INDIANA DEPARTMENT OF TRANSPORTATION

July 19, 2018 Standards Committee Meeting

STANDARD SPECIFICATIONS, SPECIAL PROVISIONS AND STANDARD DRAWINGS
REVISION TO STANDARD SPECIFICATIONS

REVISION TO RECURRING SPECIAL PROVISION AND PLAN DETAILS
808-T-190 LONGITUDINAL RUMBLE STRIPES

REVISION TO RECURRING SPECIAL PROVISION AND PLAN DETAILS
 808-T-190d CENTERLINE LONGITUDINAL RUMBLE STRIPE (PAGE 1, WITH MARKUPS)

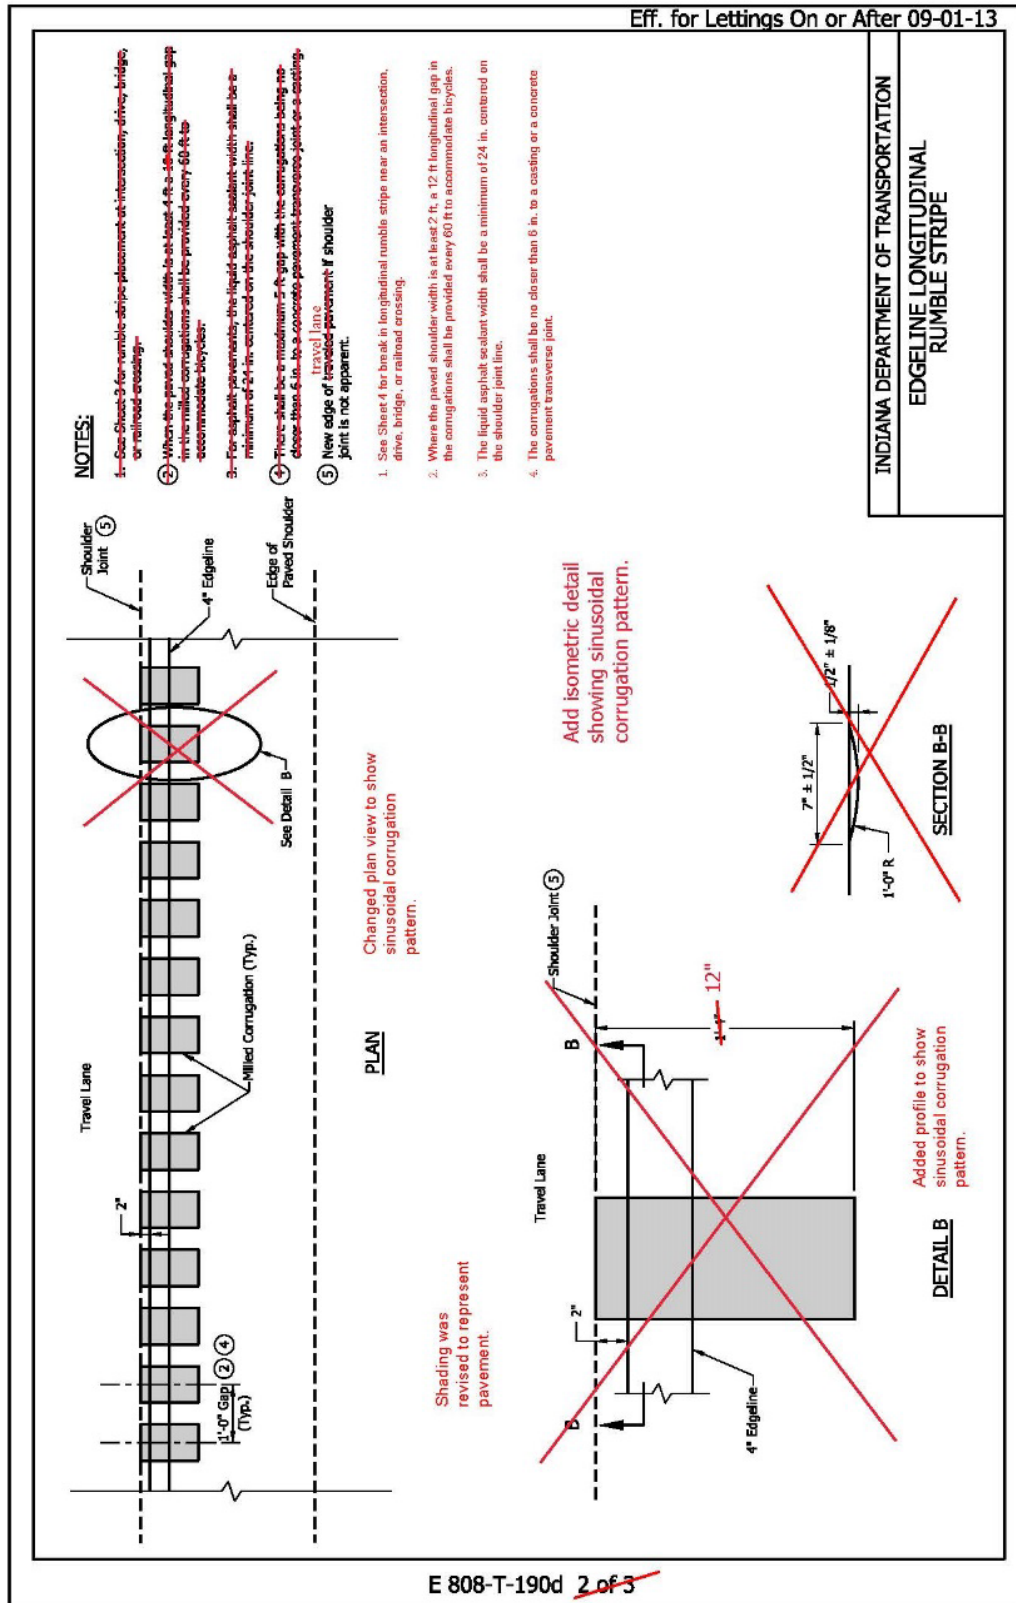
Added Index Sheet as Sheet 1 of 6
 Added New Sheets 5 and 6

Details Moved to Sheet 2 of 6

808-T-190d MILLED LONGITUDINAL RUMBLE STRIPS INDEX SHEET (PAGE 1, DRAFT)

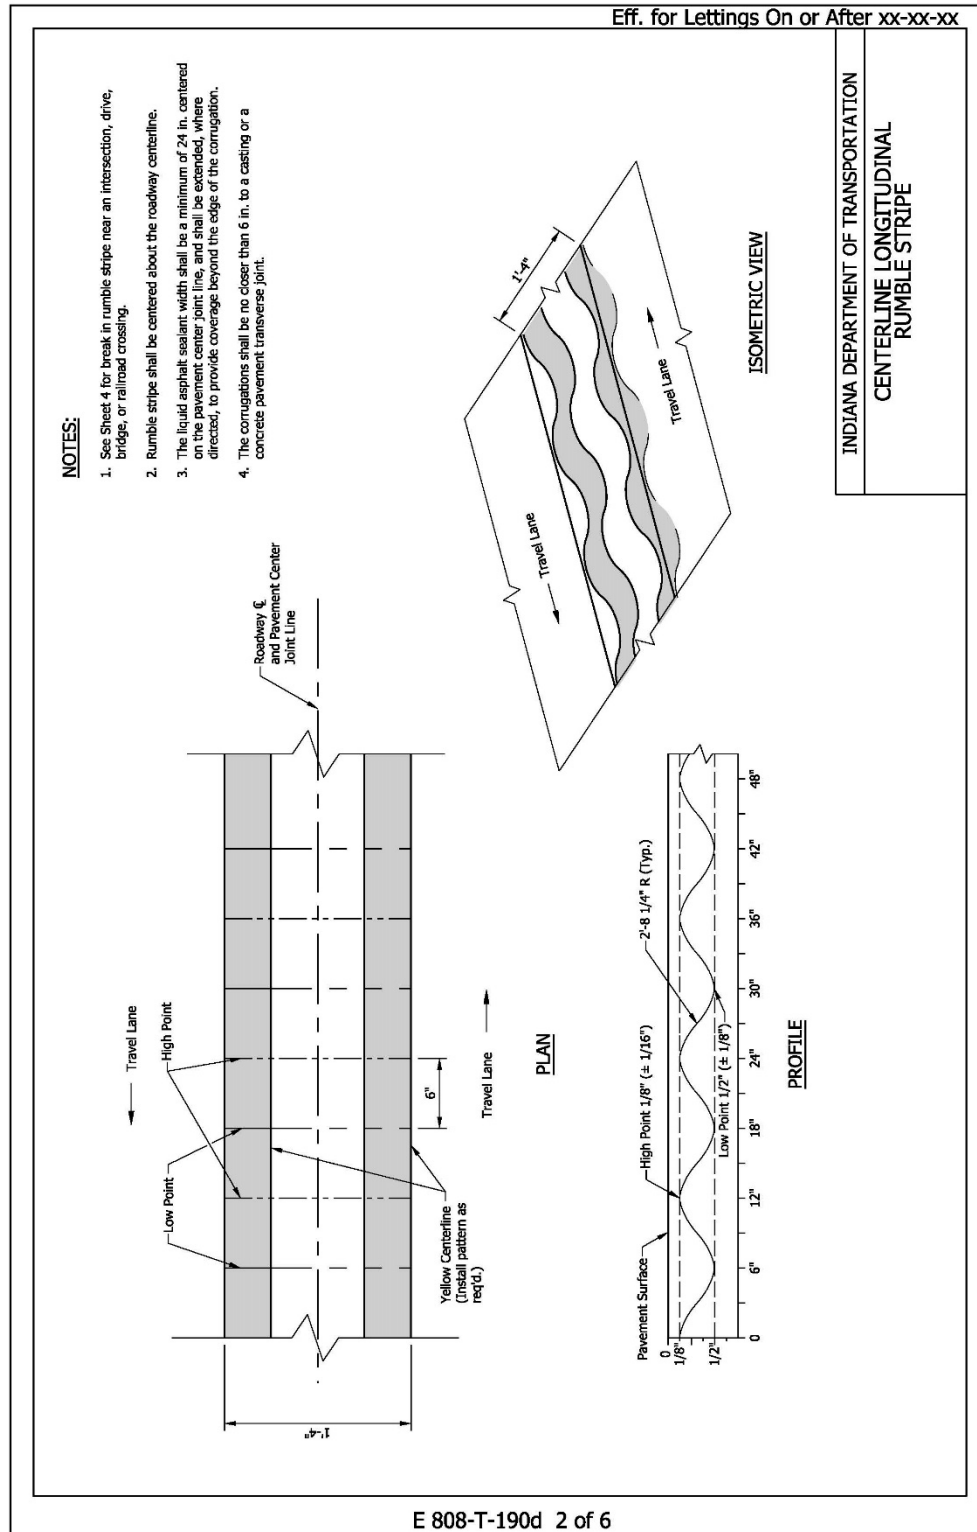
INDEX	
SHEET NO.	SUBJECT
1	Index
2	Centerline Longitudinal Rumble Stripe
3	Edgeline Longitudinal Rumble Stripe
4	Break in a Longitudinal Rumble Stripe near an Intersection, Drive, or Railroad
5	Shoulder Longitudinal Rumble Strip
6	Break in a Shoulder Longitudinal Rumble Strip near an Intersection, Drive, or Railroad

REVISION TO RECURRING SPECIAL PROVISION AND PLAN DETAILS
 808-T-190d CENTERLINE LONGITUDINAL RUMBLE STRIPE (PAGE 2, DRAFT)

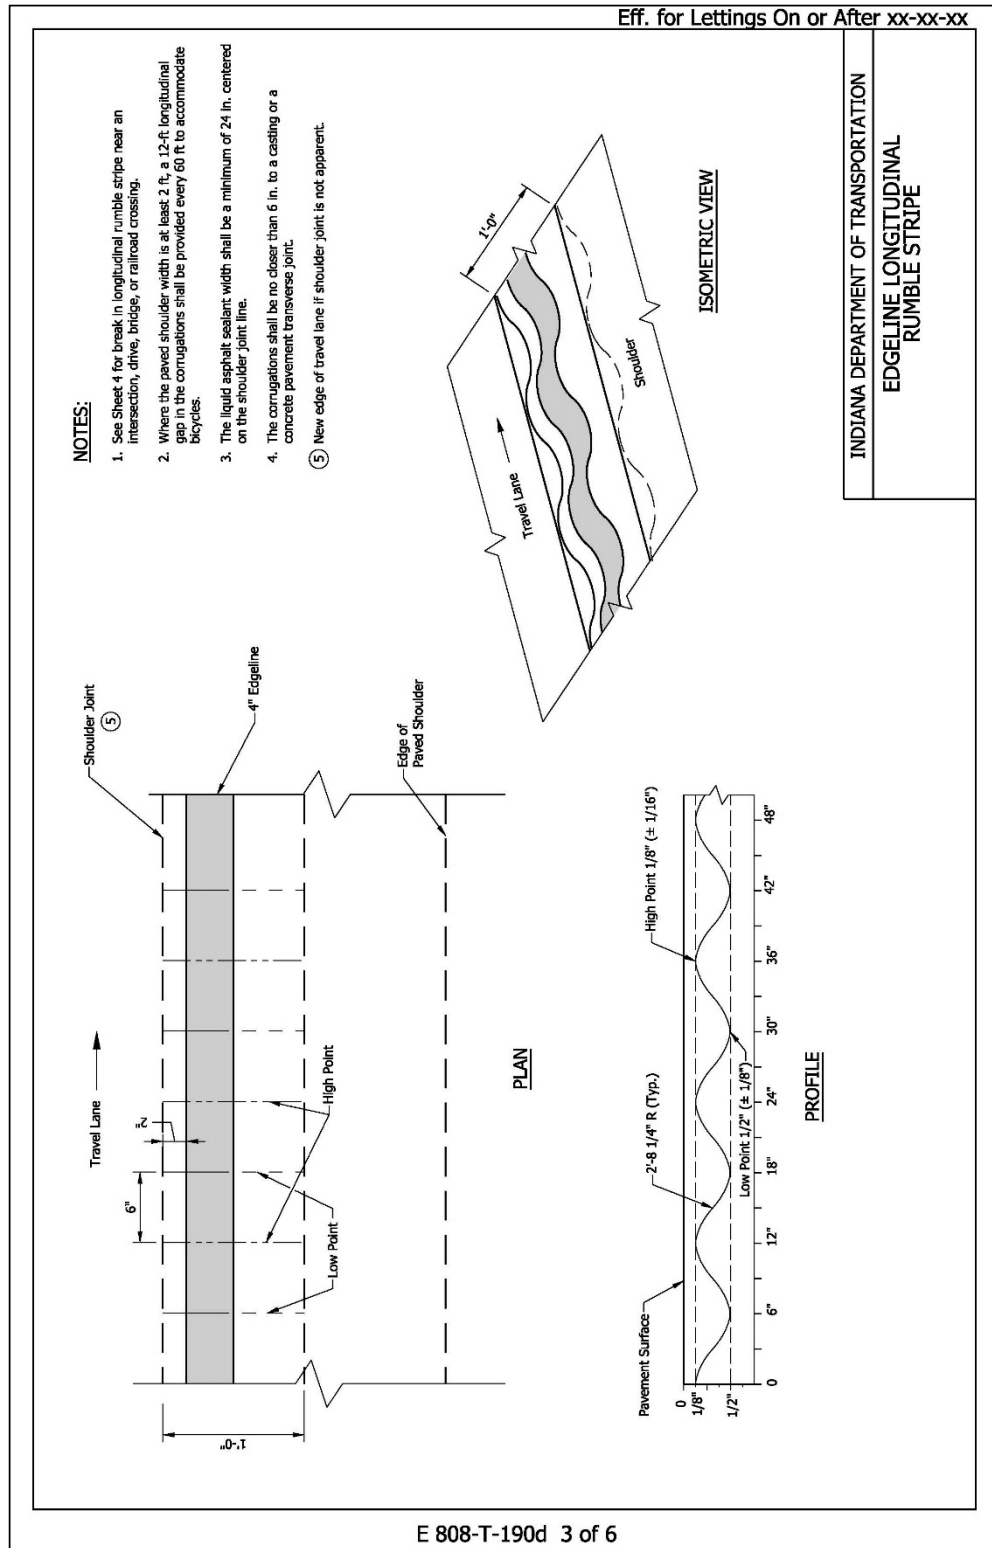
PROPOSED SOLUTION: Revise the recurring special provision and plan detail to use the sinusoidal corrugation pattern for rumble stripes.
